SCALE:	UNIT:	DRN BY	DATE	NUTEK CORPORATION			
1:1	M/M	DANIEL	2011/01/18	TITLE CSI OE 1-BTN TX			
MATERIAL		CHK BY		4360307			
FINISH		APPD BY		SIZE	DEPT	DRAWING NO	REV
CODE		SHEET	OF	A4		98I0340-1	0

SCALE:	UNIT:	DRN BY	DATE	NUTEK CORPORATION			
1:1	M/M	DANIEL	2011/02/11	TITLE CSI OE 2-BTN TX			
MATERIAL	CHK BY	YYS		4360317 KIA MOTORS			
FINISH	APPD BY	Victor		SIZE	DEPT	DRAWING NO	REV
CODE	SHEET	OF		A4		100I0030-2	1

SCALE:	UNIT:	DRN BY	DATE	NUTEK CORPORATION			
1:1	M/M	DANIEL	2011/02/11	TITLE CSI OE 2-BTN TX			
MATERIAL		CHK BY		4360318 HYUNDAI			
FINISH		APPD BY		SIZE	DEPT	DRAWING NO	REV
CODE		SHEET	OF	A4		100I0030-1	1

P/N: IAAJ7001

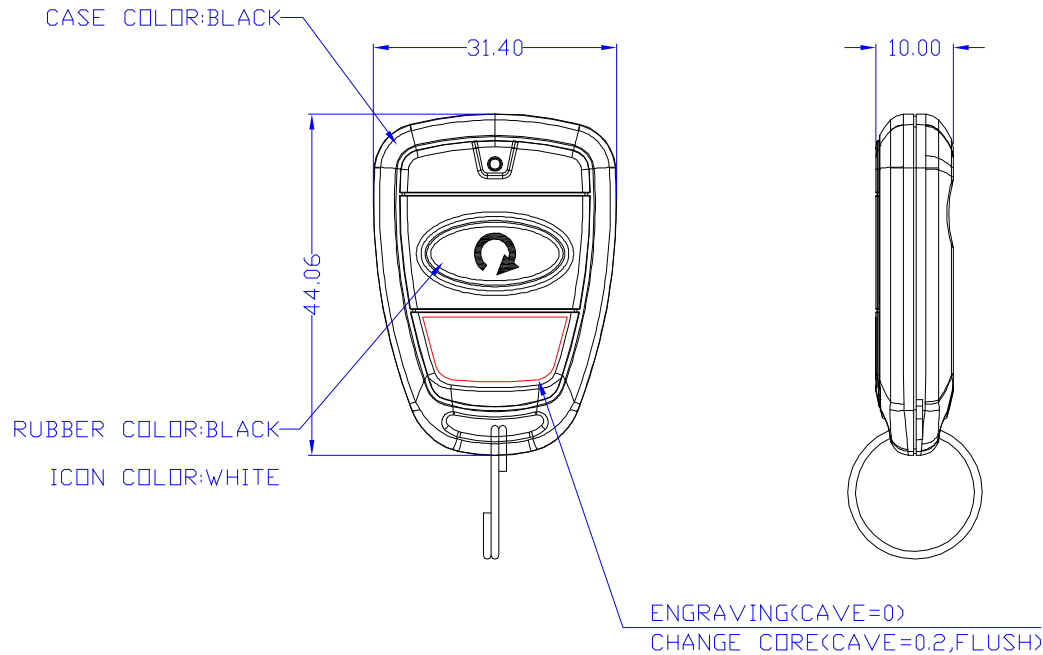
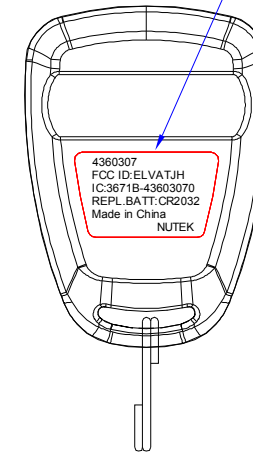
ENGRAVING (RAISED=0.2mm)
 CHANGE CORE(CAVE=0.2,TEXTURE MT-11020)

REVISIONS				
REV.	ACC.	DESCRIPTION	DRN.	DATE
△	mail:2/23	modify changecore	DANIEL	2011/2/23

P/N: IAAL0002

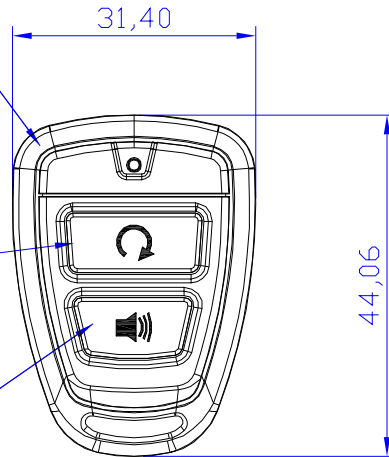
CHANGE CORE(CAVE=0.2,TEXTURE MT-11020)

REVISIONS				
REV.	ACC.	DESCRIPTION	DRN.	DATE
△	mail:2/23	modify changecore	DANIEL	2011/2/23

P/N: IAAL0001

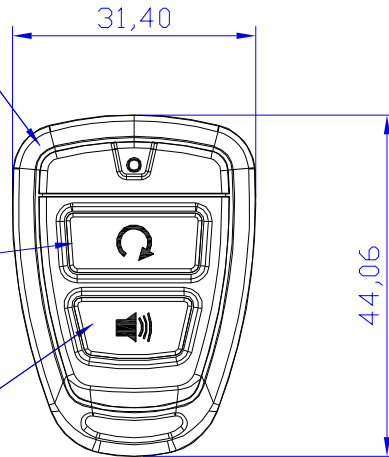
CHANGE CORE(CAVE=0.2,TEXTURE MT-11020)
